# City Plan Commission

April 7, 2020

# “West Arlington Replat of Lots 391, 392, 393, 394, 434, 435, and 436”

Preliminary Plan Minor Subdivision without street extension – Associated 3 Variance Requests

# SITE PLAN

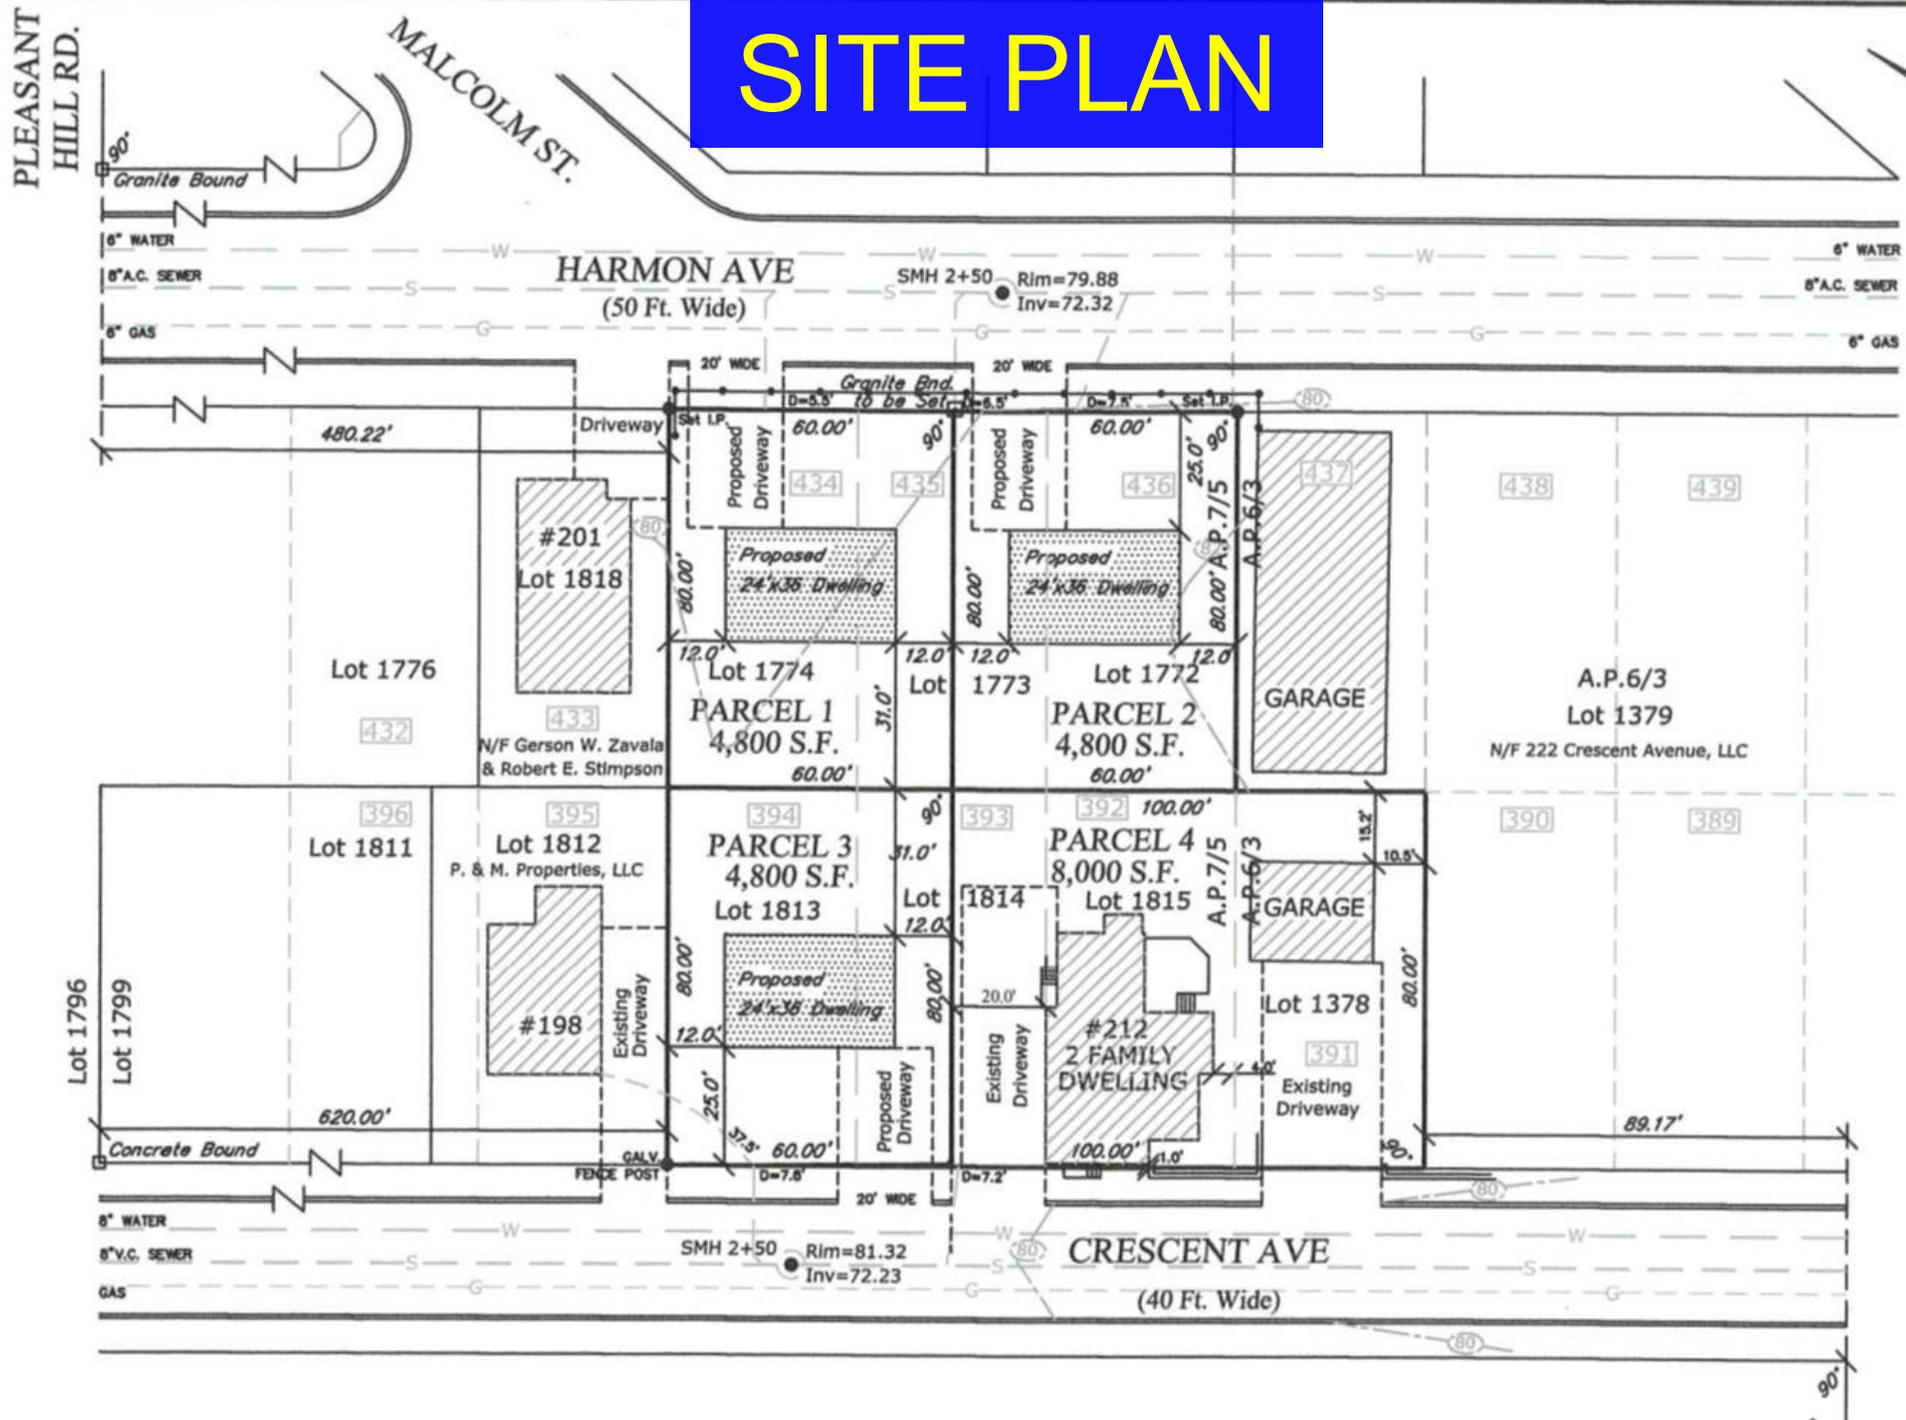
- The applicant proposes to subdivide/merge a total of 7 existing lots into 4 proposed new lots that will be larger in size. The project proposes 3 lots that will each be 4,800 sq. ft. for future single-family houses (requires ZBR approval), and 1 lot that will be 8,000 sq. ft. with a pre-existing, nonconforming two-family dwelling (no ZBR approval needed).

- The average size of residential lots within 400 feet of the subject parcels is 4,225 sq. ft., which is less than the proposed 3 substandard parcels (4,800 sq. ft.).

- Staff finds that 8,000 sq. ft. is a sufficient size to accommodate a two-family dwelling based on comparable zoning standards from the B-1 zone and the specific conditions of the subject property. Furthermore, staff finds that a two-family dwelling is not inconsistent the character of the surrounding neighborhood.

3. Three (3) of the proposed lots will require zoning relief for substandard lot size (proposed 4,800 ft<sup>2</sup> lots where 6,000 ft<sup>2</sup> is required). Should approval be granted through a separate decision by the Zoning Board of Review, the project will be in compliance with the City's zoning ordinance.

Staff finds this proposal consistent with the standards for required findings of fact set forth in RIGL Section 45-23-60 as well as with the City of Cranston's Subdivision and Land Development Regulations. Staff therefore recommends that the Planning Commission adopt the documented findings of fact and approve the Preliminary Plan application, subject to the conditions denoted below.

1. Applicant shall receive variance approval for substandard lot area from the Cranston Zoning Board of Review prior to filing the Final Plan Application with the Cranston Planning Department.
2. Payment of the Eastern Cranston Capital Facilities impact fee in the amount of \$1,780.38 (3 new units) must be submitted at the time of final plat recording.
